## Product Change Notification / SYST-24EVEA235

ERRATA - MCP2518FD Silicon Errata and Data Sheet Clarification Document Revision

## MCP2518FD Silicon Errata and Data Sheet Clarification

**FIGURE 1: MAXIMUM DELAY BETWEEN SPI BYTES**

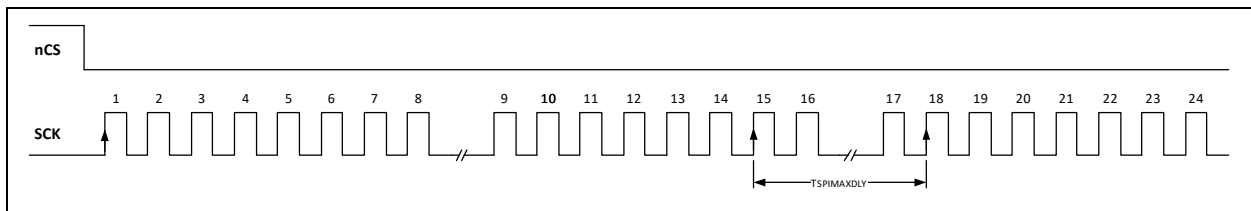
#### TX MAB underflow due to long delays between SPI bytes:

The SPI interface blocks the CAN FD Controller module from accessing RAM between the 15th and 18th rising edge of SCK, during an SPI READ instruction, while accessing RAM.

If the CAN FD Controller module is blocked for more than TSPIMAXDLY, a TX MAB underflow can occur.

Keep the delay between two SPI bytes shorter than TSPIMAXDLY; see [Figure 1](#).

The maximum allowed delay between two bytes depends on which CAN Message Frame is transmitted, and on the selected Nominal Bit Time (NBT) and Data Bit Time (DBT). [Table 1](#) lists TSPIMAXDLY for the worst-case scenarios.

For example, TSPIMAXDLY is 8.5  $\mu$ s for a CAN FD frame at 500 kbps/2 Mbps. In comparison, an SPI byte takes 0.67  $\mu$ s at 12 MHz SCK. A delay of ten times the duration of one SPI byte could cause a TX MAB underflow. It is highly unlikely for an MCU application to introduce such a long delay, but this error could occur when running an operation system, such as Linux<sup>®</sup> on a slower MPU.
